Determination 2018/012

The refusal to issue two code compliance certificates for alterations and additions to a house at 433 Marine Parade, Napier

Figure 2: Diagrammatic Roof Plan

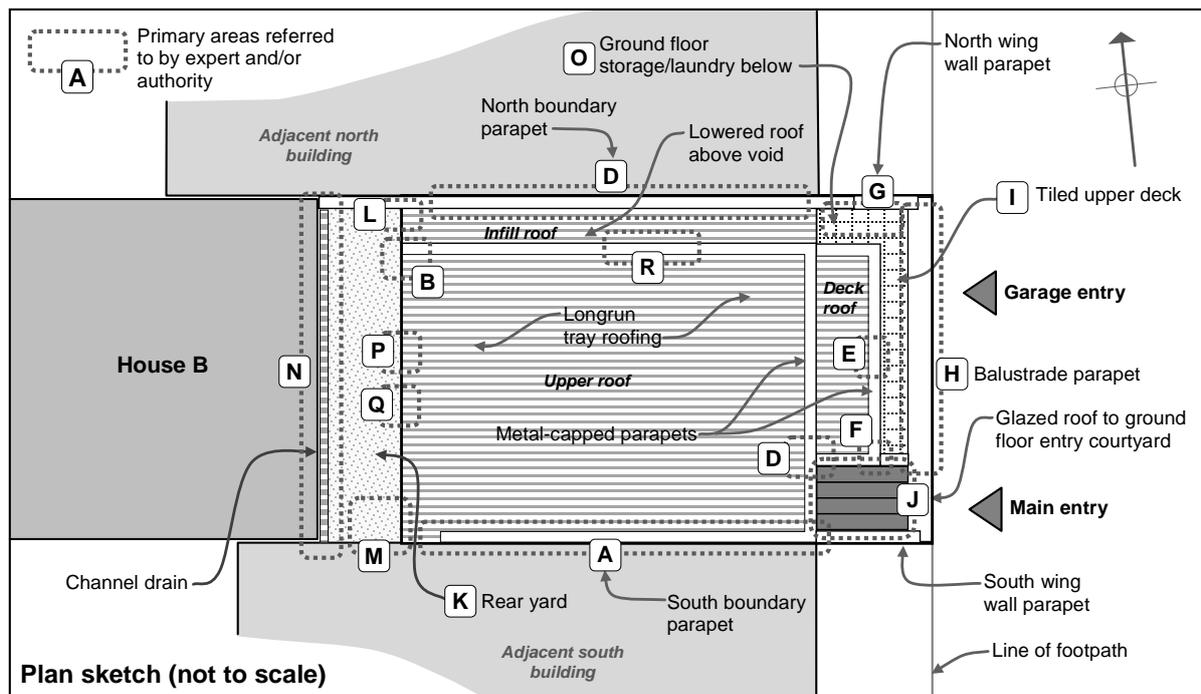
1. Parapet capping/wall junction (Area D)
2. Unpainted and cracked fibre cement to roof parapet (Area A)
3. Roof/wall flashing (Area M)
4. Unpainted fibre cement patch to roof parapet above lounge (Area A)
5. Deck posts/deck floor junctions (Area I)
6. Deck post/balustrade parapet junction (Area F)
7. Drainage inspection junction (Area L)
8. Adjacent north building wall/cladding junction (Area L)
9. Cladding crack (Area L)
10. Unsealed pipe penetration to upper west cladding (Area L)
11. Entry roof glazing/adjacent south building wall junction (Area J)
12. Balustrade parapet/north wing wall junction (Area G)

13. North wing wall/deck tiles junction (Area G)
 14. Lack of maintenance to exterior cladding
 15. Floor clearances (Area J)
 16. Weathertightness of entry courtyard glazed roof (Area J)
 17. Weathertightness of deck internal gutter (Area H)
 18. Weathertightness of deck floor (Area I)
 19. Weathertightness of roofing
 20. Waterproofing of upper ensuite shower.
- 3.11.3 In a phone call with the applicant on 26 January 2015, the authority confirmed that the above items required addressing or a determination should be sought.
- 3.12 The Ministry received an application for a determination on 27 October 2017, which was accepted on 3 November 2017.

- column cladding butts against the deck floor tiles, with sealant at the junction
- high moisture levels at the bottom of the central column, although drillings appeared in reasonable condition (Area E)
- slightly elevated moisture levels at the column/balustrade parapet top (Area F).

- timber framed parts of balustrade are clad in direct fixed textured fibre cement
- balustrade tops are wrapped in fibreglass mesh reinforcing then texture coated
- balustrade tops slope 4° to 5° towards the deck area
- although the south balustrade cladding butts against deck floor tiles, moisture levels are only 12% to 15%, with no evidence of associated moisture penetration – likely due to a membrane upstand behind the cladding.

- the deck floor slopes at an average of 0.7° towards the north and east
- there is a coved tile upstand at the deck/west wall junction, with low 10% moisture reading in the bottom plate
- the threshold under the service door to the north void is clad, with the cavity sealed off by the deck tiles but no indication of water entry
- the deck floor falls towards a membrane lined gutter along the east balustrade, with two gutter outlets but no overflow
- there was no evidence of moisture entry into the garage below the gutter, with low moisture readings in the garage ceiling lining.

- an unconventional flashing extends over the original concrete wall/deck tile junction, with evidence of water penetration into the paint cupboard below
- flaking paint, efflorescence and ‘highly elevated’ surface moisture levels were observed on the north wall of the paint cupboard beneath the deck (Area G)
- in the cupboards beneath the roof void (Area D), there was no evidence of current moisture penetration although paint flaking indicated historic water entry (likely prior to the 2006 alterations which included the roof void).

- north and west wall EIFS below glazing is fixed over cavities
- cavity above entry doors restricted by flashing under cladding
- low moisture levels in ceiling to north of glazing
- low moisture level in ceiling trim below glazing/south wing parapet wall, where authority was concerned about flashing
- no evidence of moisture penetration resulting from roof glazing.

- although the flashing to the west end of the roof parapet between the upper roof and infill roof is vulnerable, some protection is provided by the EIFS cavity and there is no evidence of current water entry (Area B)
- the south boundary wall/roofing junction at the south west corner of the upper roof is not securely fixed and not weathertight, with no indications of current moisture penetration but cladding cracks below that risk water entry (Area M)

- fibre cement cladding to south boundary parapet has been patched and painted, with no indication of moisture penetration below (Area A)
- the near flat parapet capping to the deck canopy roof is face-fixed at the junction with the wall, with no indications of moisture penetration and the EIFS cavity able to drain any minor penetration onto the roof (Area D).

- the concrete/textured fibre cement junction to the north west corner of the lower floor is cracked with no underlying flashing – a cut-out (see paragraph 5.3.2) revealed ‘highly decayed’ framing at the base of the junction (Area L)

- there are also cracks at the north west corner of the upper floor between the upper level EIFS cladding and the concrete boundary walls that require repair, although there are no signs of water entry due to the drained cavity behind the EIFS (Area L)

- there are also cracks at the south west corner of the upper floor that require repair, although there are no signs of water entry due to the drained cavity behind the EIFS (Area M)

- there are no control joints to the lower textured fibre cement cladding, with a fine vertical crack above and below the bathroom window (Area P)
- a pipe penetration below the upper EIFS is unsealed (Area L)

- a vertical pipe above the west gully trap is partially embedded into the direct fixed cladding, making it vulnerable to water entry (Area Q).

- bottom of the deck columns (Area E and Area F)
- concrete wall/deck tile junction at the north wing wall (Area G)
- flashing to the west end of inter-roof parapet (Area B)
- south boundary wall/roofing junction at the SW corner (Area M)
- cracks to the inter-cladding junction at SW corner (Area M)
- cracked and leaking inter-cladding junction at NW corner (Area L)
- unsealed pipe penetration at the NW corner (Area L)
- the lack of control joints to west wall textured fibre cement (Area P)
- embedded vertical pipe above west gully trap (Area Q)

7.2.7 Because the identified cladding faults occur in discrete areas, I am able to conclude that satisfactory investigation and rectification of areas outlined in paragraph 7.2.4 will result in the external building envelope of House A being brought into compliance with Clauses E2 and B2 of the Building Code.
